APPLICANT: DUQUESNE LIGHT COMPANY

FACILITY: BEAVER VALLEY UNIT 2

SUBJECT: SUMMARY OF MEETING ON MARCH 4, 1986: FIRST PROGRESS REPORT
MEETING ON WHIPJET

FERRITIC STEEL TEST MATRIX
(3 HEATS BASE & 3 HEATS WELD)

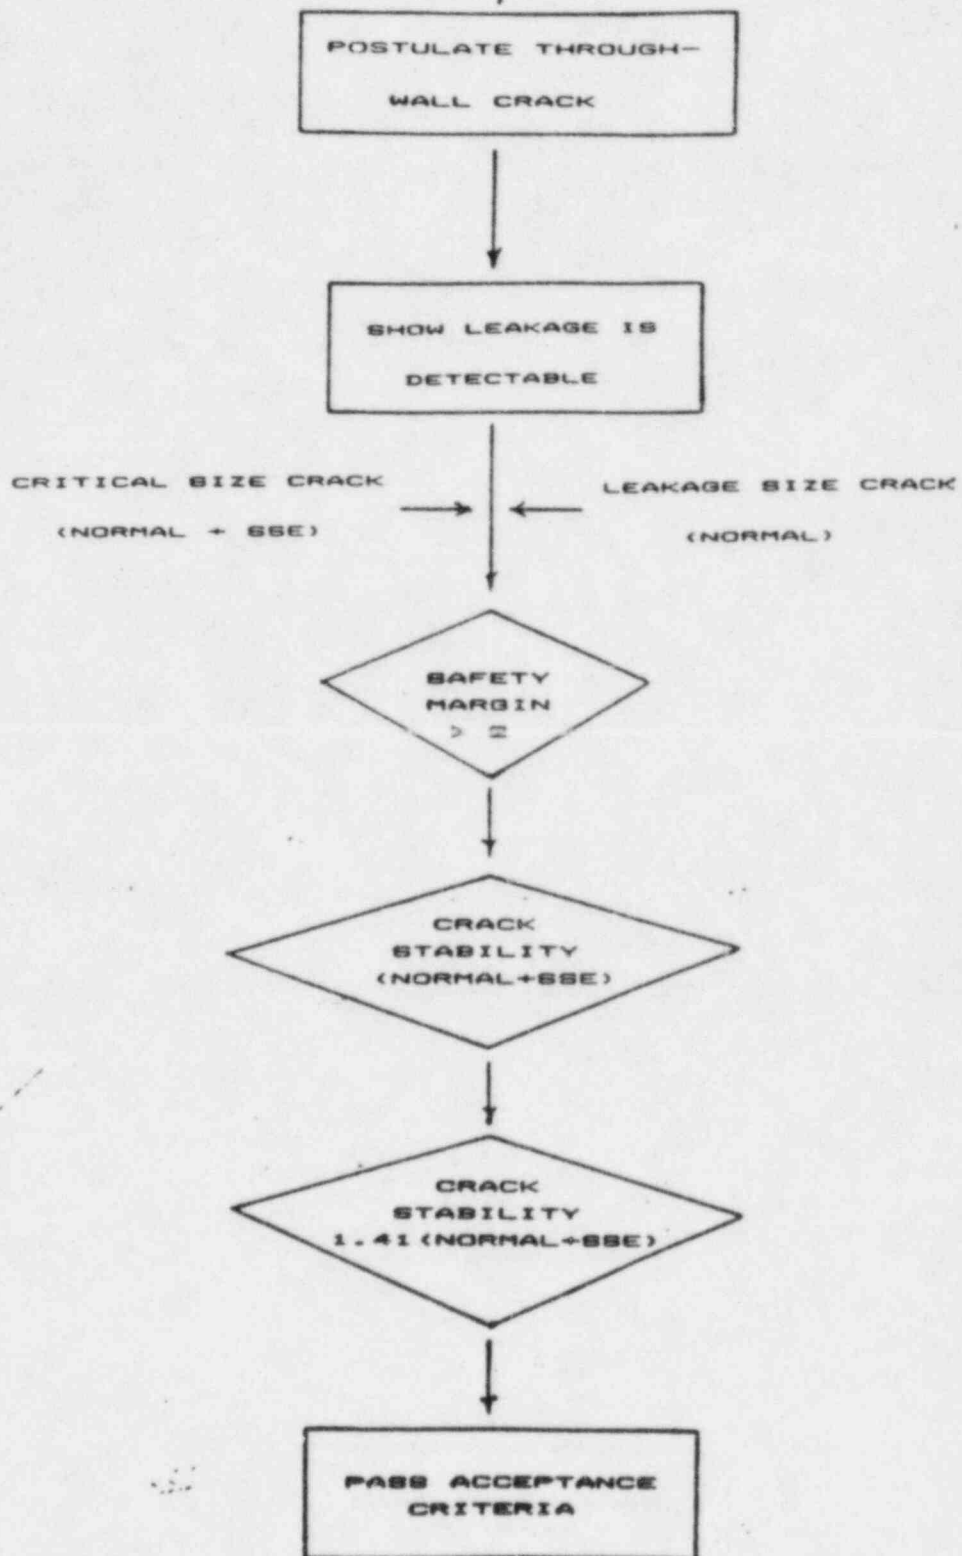
10. The testing program for J-R curves is for ferritic piping. DLC is planning to rely on stainless steel data base rather than testing. DLC should provide the NRC with austenitic weld data for our review prior to beginning their testing program.
